SECTION 92 DOCUMENTS – VOLUME 4

**5 REEVES ROAD, PAKURANGA HEIGHTS (EB2);
207 TI RAKAU DRIVE, PAKURANGA HEIGHTS
(EB3R)**

FINAL S92 RESPONSE FOR EB3R

Re. Response to Council further information requests for the EB3R Application Package

Figure 1 - MCC108699's design as lodged (left) and as now proposed (right)

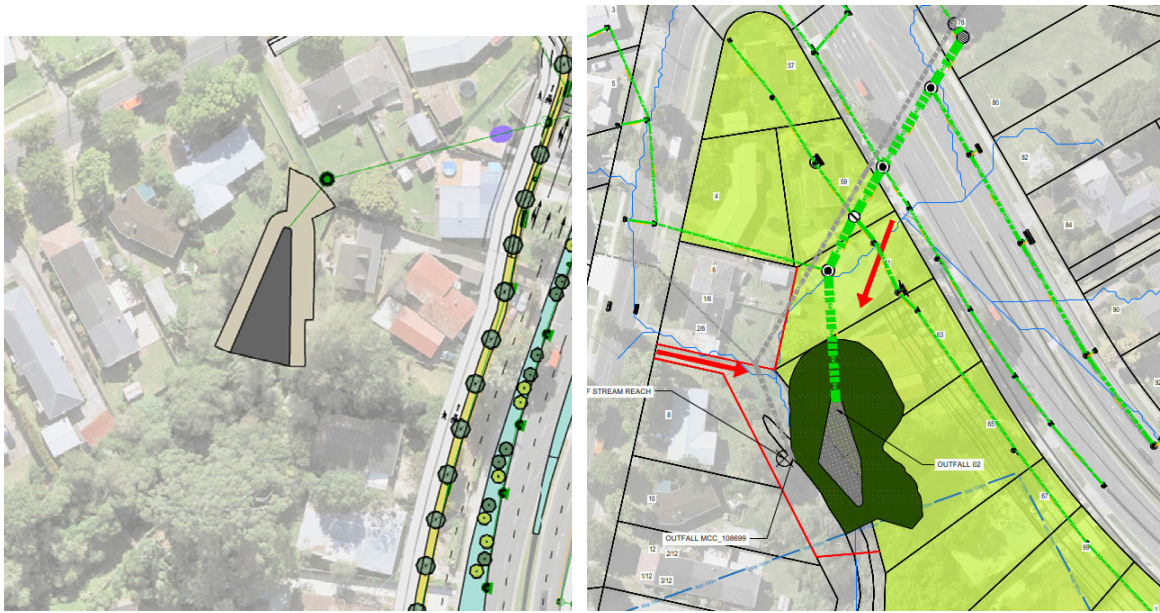
It is noted that AT has sought to minimise both the disturbance and permanent occupation footprint of these outfalls. This includes a redesign of MCC108699, which results in the outfall structure being moved partially outside of the existing stream channel. The relocation of this outfall is clearly show in Figure 1, with the outfall now located further northwards of the existing stream channel with reduced effects on that stream.

It is noted, as per the response to Query 106, that additional consents are required for three outfalls (MCC108699, MCC108703 and MCC108707). The ecological assessment prepared for these works (**Attachment 6**) details the current compromised nature of the three affected streams and that outfall works in these locations are appropriate. Furthermore, the ecological assessment also identifies the construction practices required to manage the outfalls' construction, as well as the offsetting required for the permanent occupation of streambeds.

OUTFALL MCC_108707

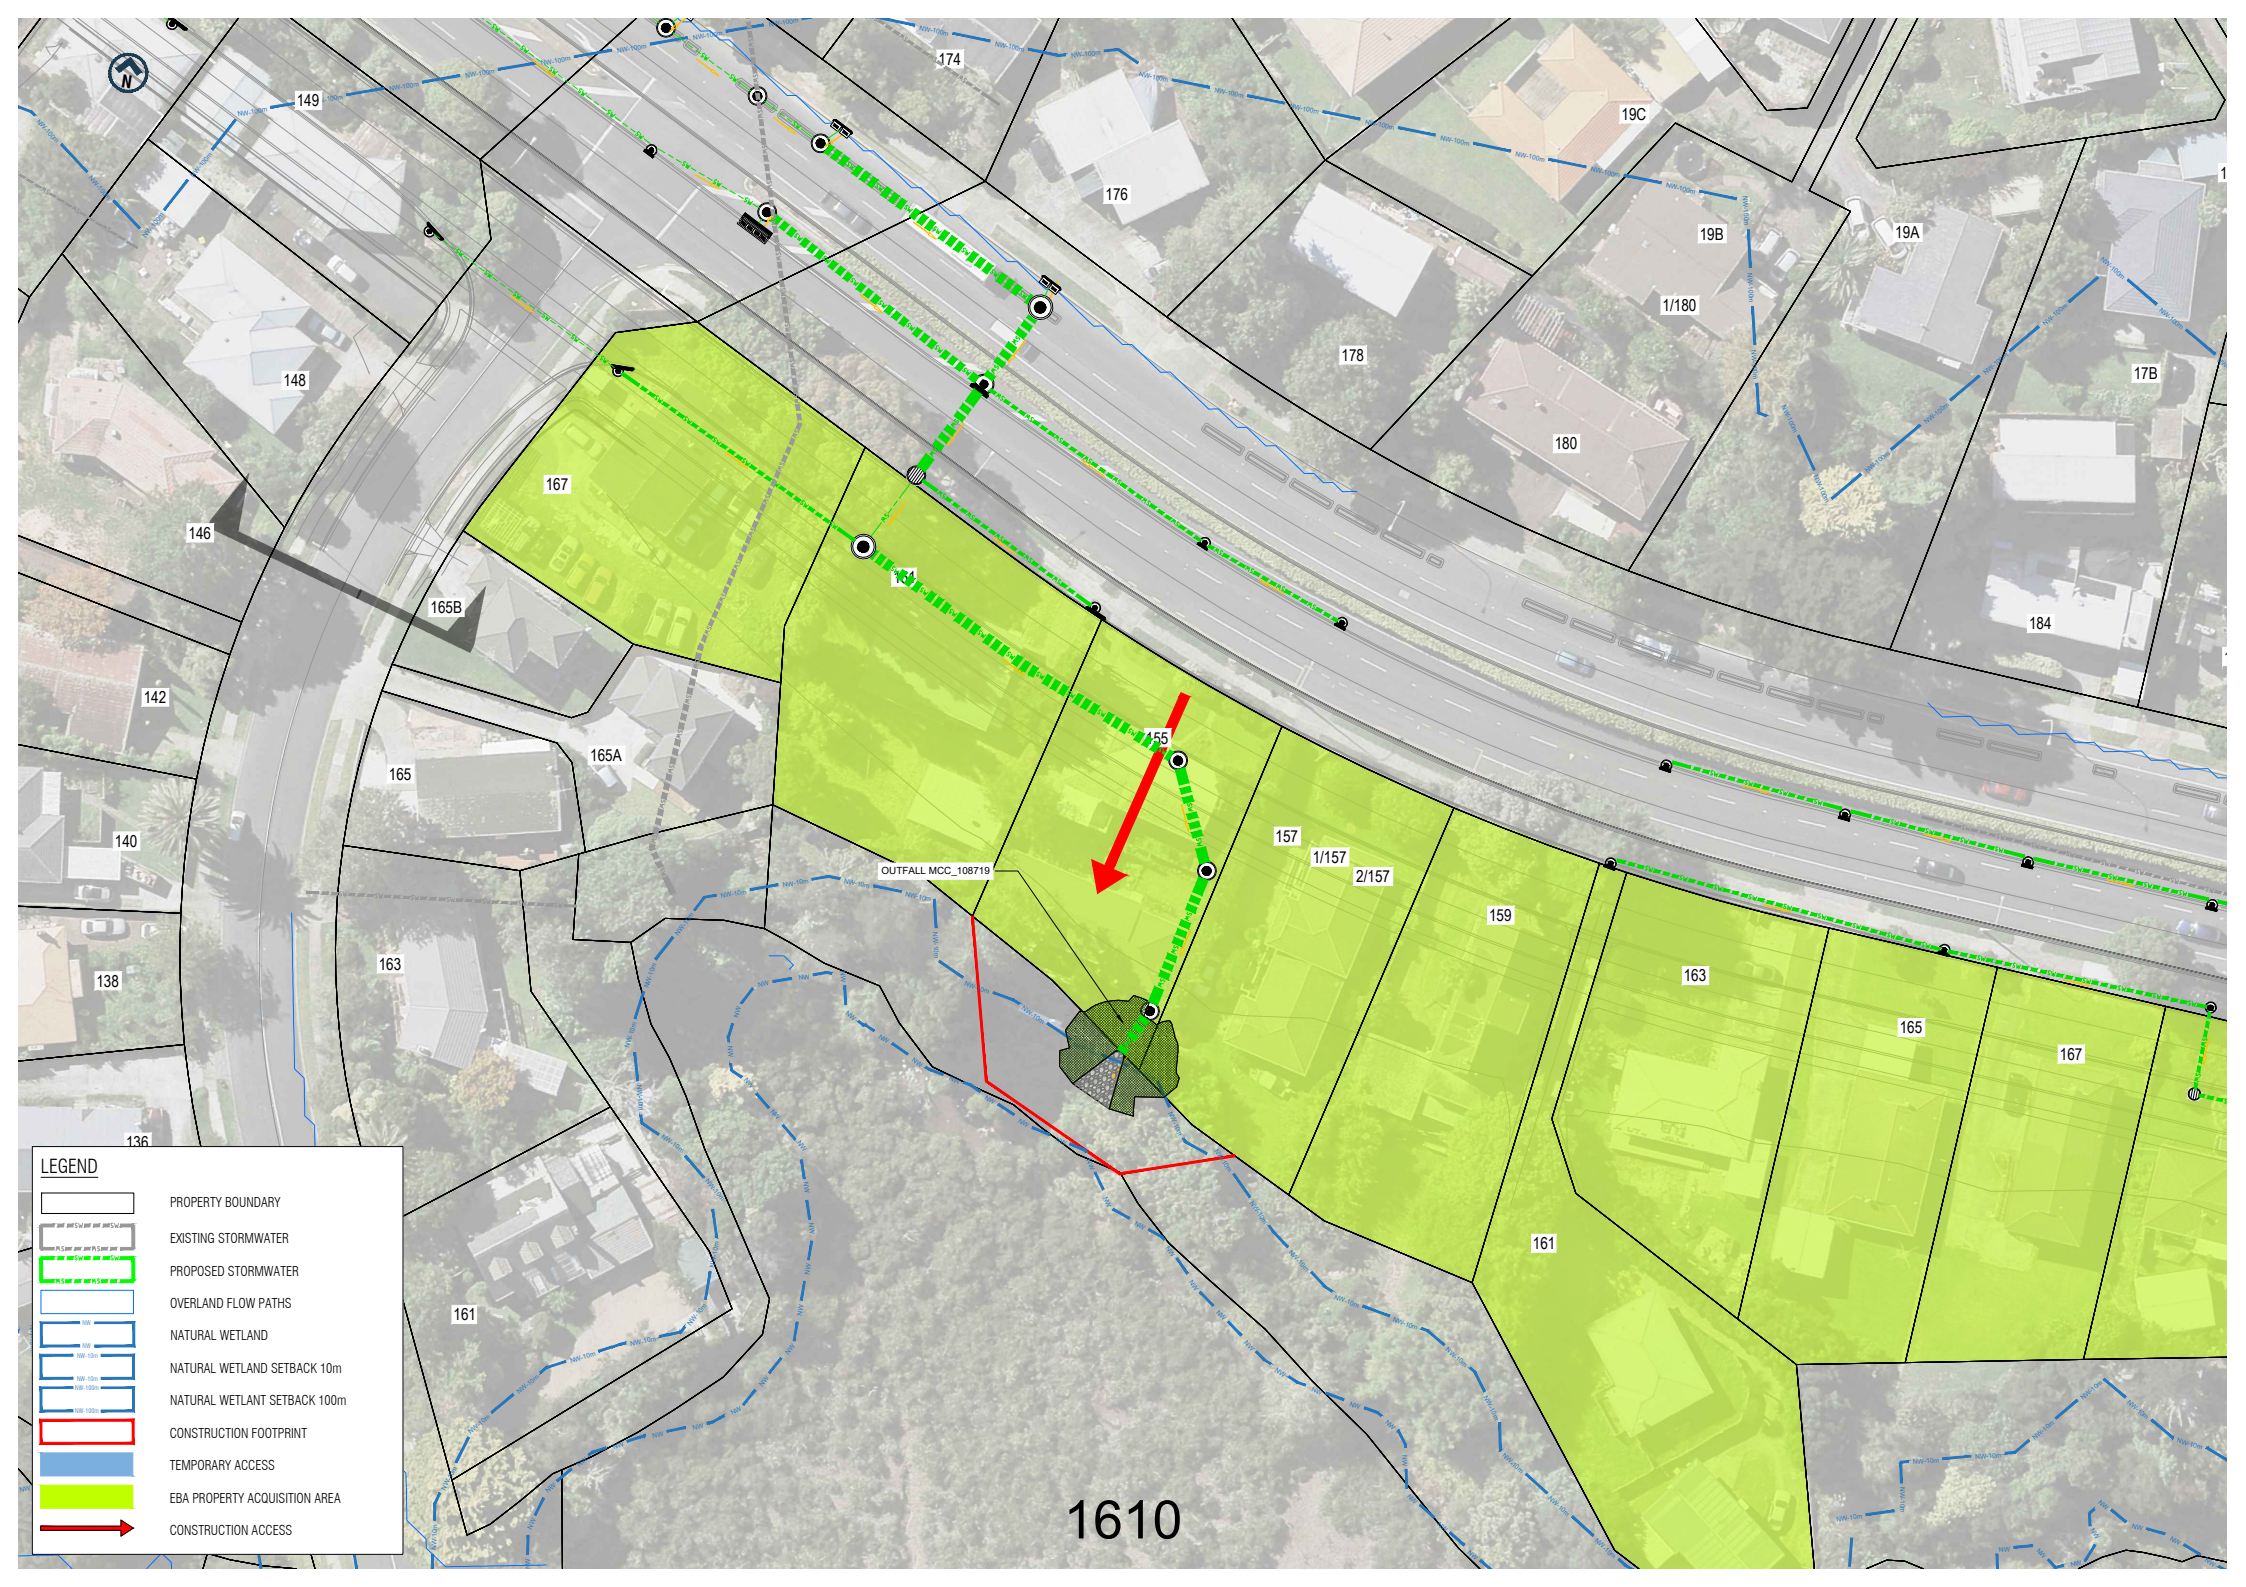
108. *It is currently unclear whether consent under E3 would be required for the works associated with stormwater outfall and 'vegetated riprap' as shown on the ESCP drawings SK-000011 and SK-000012, which are located adjacent to or within 'streams 3a and 3b' as shown on figure 5-11 of the ecological effects assessment.*

- a. Please locate the stream extent on the drawings to clarify whether works and/or structures will be located within the bed of a stream.*
- b. Please provide the dimensions of the proposed structures located within the bed of the stream on the relevant drawings. (Dimensions of the existing structures would be helpful as a comparison to the proposed structures).*
- c. Please confirm the total length of stream works proposed, as applicable.*
- d. Please assess the proposed structures and works against the rules of chapter E3 of the AUP:OP and (regulations of the NES-F where applicable). Please either:*

Updated outfall drawings are provided as **Attachment 1**, with further details provided in **Attachments 5 and 6**. The additional consent triggers, in relation to streamworks are provided in the response to Query 106. Commentary regarding permanent occupation of streambeds is provided in the response to Query 107.

Construction access has been added to the drawings provided as **Attachment 1**. In general, access will be in the immediate location of the outfall and generally run parallel to the stormwater line connecting to the outfall structure. The same construction access will be used to install the pipeline and the outfall.

Attachment 2 – Plan of Edgewater Shops Car Park

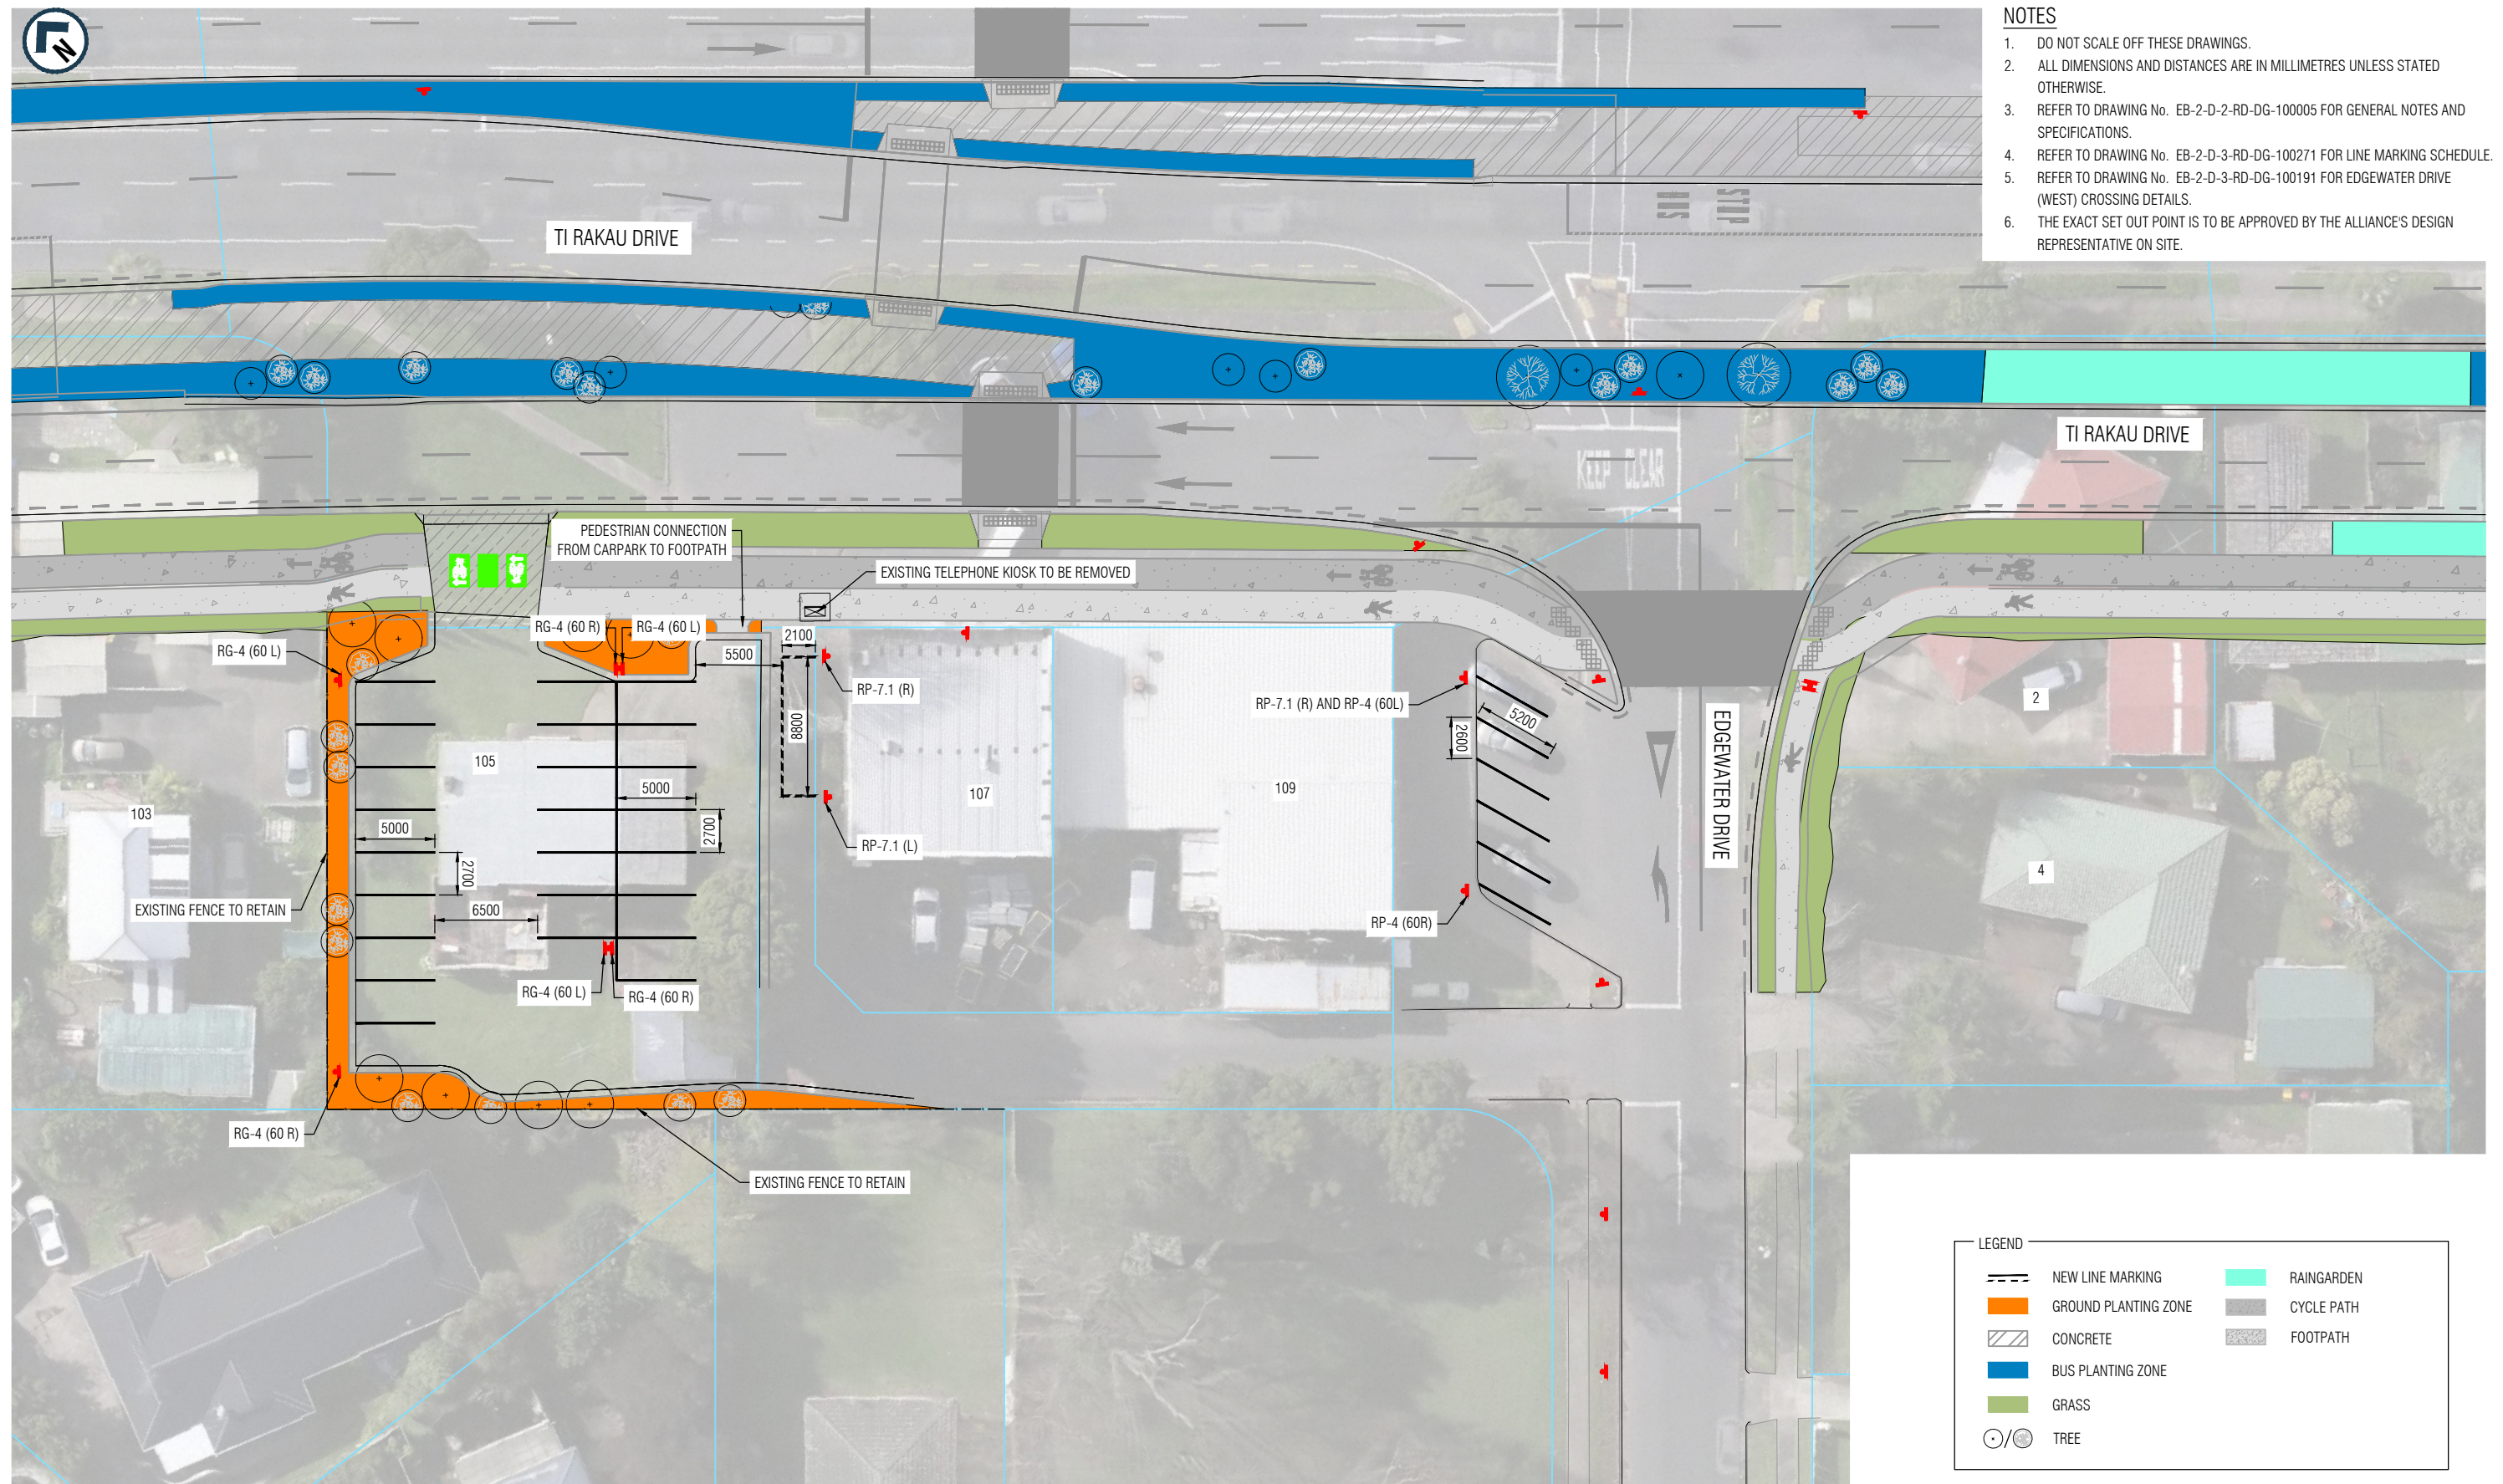
15. *Information on this parking area(s) is spread between a number of documents and plans. In order to understand the functioning of the parking area and its interface with neighboring properties and streetscape in both configurations, please provide consolidated scaled plans which set out:*
- a. The carpark access to enable assessment of the parking area against the relevant access and parking standards within E27 of the AUP:OP;*
 - b. Pedestrian connections between the carpark and the Edgewater Shops the parking area is designed to serve;*
 - c. Landscaping (if relevant); and*
 - d. Boundary treatments with adjacent properties.*
- Please also provide details of any lighting and/or security arrangements for this parking area.*

A plan of the car park is provided as **Attachment 2**, which demonstrates compliance with Chapter E27 of the AUP(OP) and shows the pedestrian connection to the Edgewater Shops. It should be noted that the car park has also been designed to meet AT's engineering standards. Please note that no new lighting is proposed, while existing boundary fencing will be retained around the edge of the car park. Boundary landscaping comprising a mix of grasses, shrubs and trees will be planted. Landscaping for the car park will be confirmed through the development of the Urban Design and Landscape Plan (UDLP), which is a requirement of the UDLP conditions in AT's proposed conditions set.

Summary of Structural Elements for Eastern Busway Stormwater Outfalls

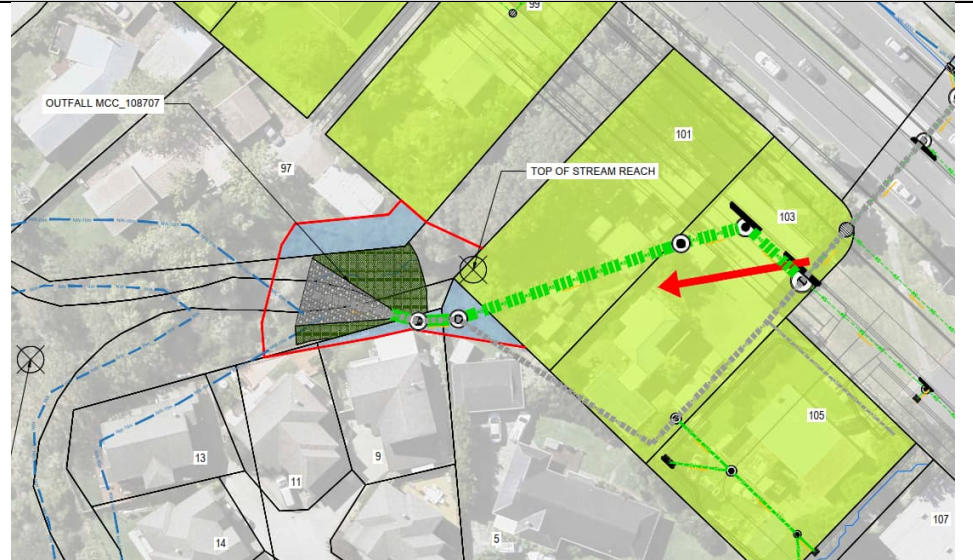
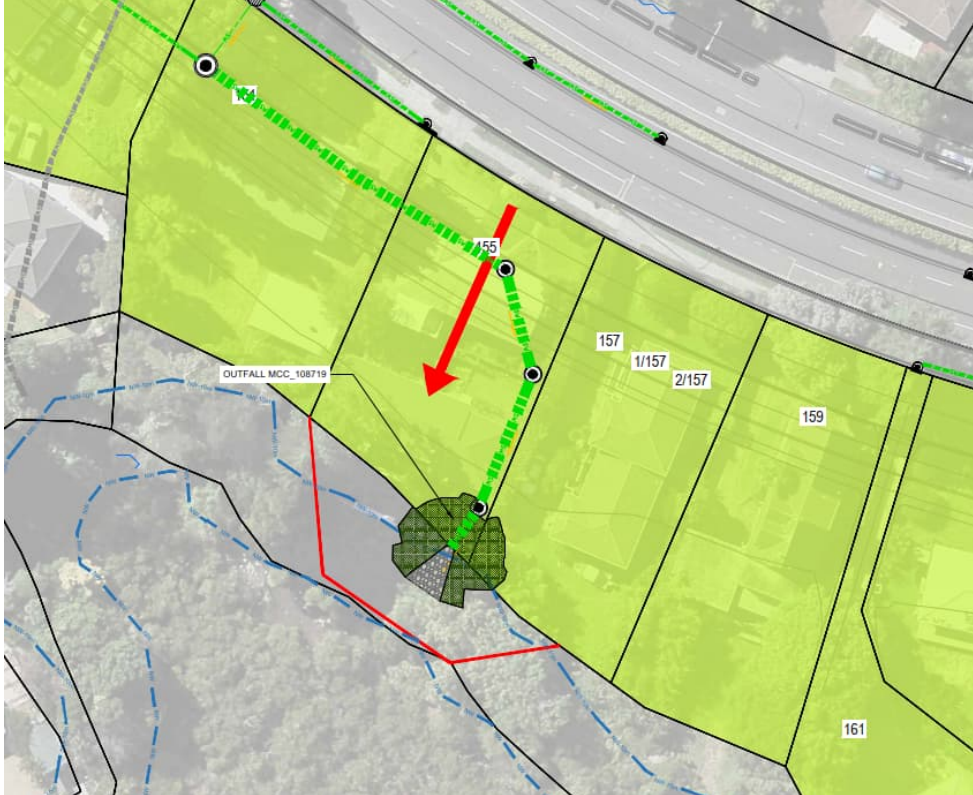
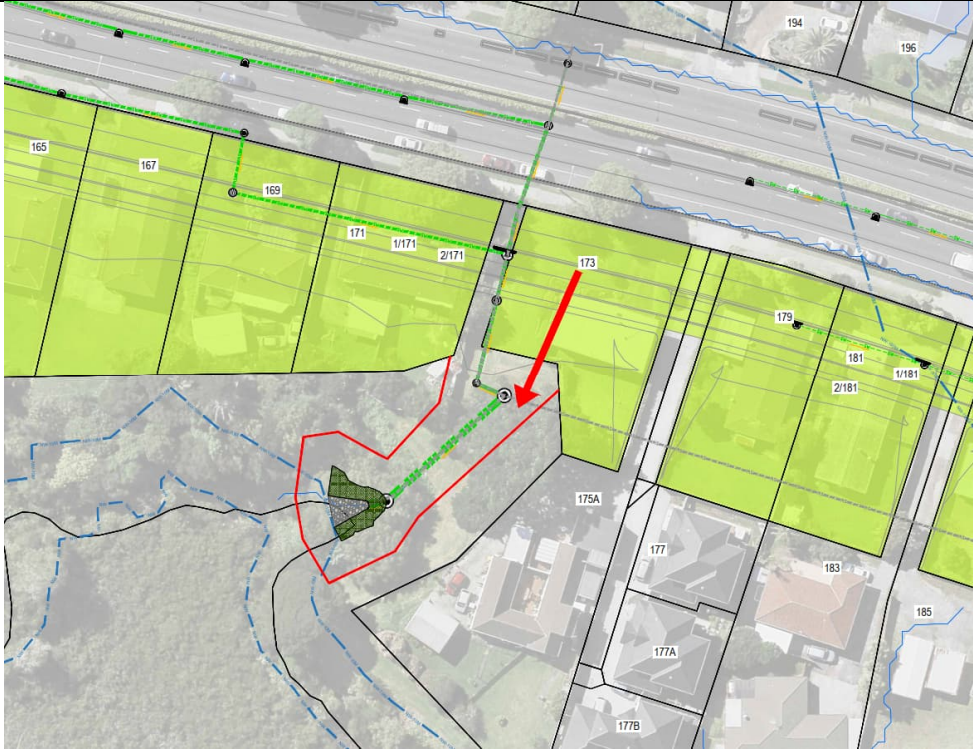
95. *As a general observation, the reference / labels used for the stormwater outfalls vary across the documents (e.g. AEE, ecological assessment reports, Erosion & Sediment Control Plan (ESCP) Report, drawings). For ease of reference, please provide a table that identifies the location of each outfall (e.g. a screenshot of the aerial image and address) and the reference relative to each document.*

and streamworks rules. These triggers are further detailed in the response to Query 106 and in **Attachment 5**.
